Access Compliance Report

Public Rights-of-Way

Intersection ID: 21445	Main Street: CHAMPAIGN_ST	Cross Street: COTILLION_AV	Location: S
ADA ID: 01E3BB387AB8	Ramp Type: Directional1	Initial Pass/Fail: Fail	Overall Compliance: No
		Severity Score: 10

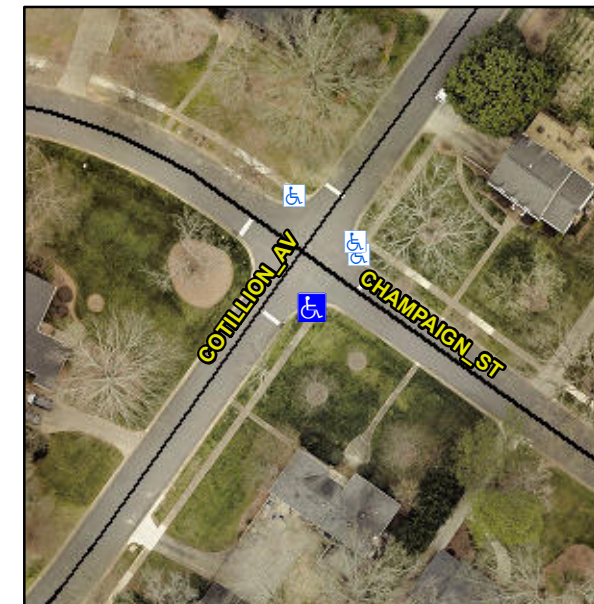
R304.5.1, R304.5.3

Compliance	Description	Data	Compliance	Description	Data
N/A	Ramp Length (in)	300.0	N/A	Grade Break?	N/A
No	Ramp Width (in)	47.0	N/A	Grade Break Slope (%)	0.0
Yes	Ramp Slope (%)	8.1	N/A	Grade Break XSlope (%)	0.0
No	Ramp XSlope (%)	4.1			
N/A	Flare Type LT	N/A	N/A	Flare Type RT	N/A
N/A	Flare Slope LT (%)	N/A	N/A	Flare Slope RT (%)	0.0
N/A	Flare Traversable LT?	N/A	N/A	Flare Traversable RT?	N/A
N/A	Landing Length (in)	0.0	N/A	DWS Provided?	N/A
N/A	Landing Width (in)	0.0	N/A	DWS Contrast?	N/A
N/A	Landing Slope (%)	0.0	N/A	DWS Length (in)	N/A
N/A	Landing X Slope (%)	0.0	N/A	DWS Full Width?	N/A
N/A	Landing Curb? (Y/N)	N/A	N/A	DWS Offset LT (in)	N/A
N/A	Shared Landing?	N/A	N/A	DWS Offset RT (in)	N/A
N/A	Gutter Ponding?	0.0	N/A	Gutter Slope (%)	N/A
N/A	Gutter Lip Ht (in)	0.0	N/A	Gutter X Slope (%)	N/A
N/A	Painted X Walk1?	No		Road Slope (%)	0.3
	X Walk 1 Direction	To N		Road X Slope (%)	3.9
	X Walk 1 Width (in)	N/A		Clear Space?	N/A

Remove & Replace Entire Ramp.
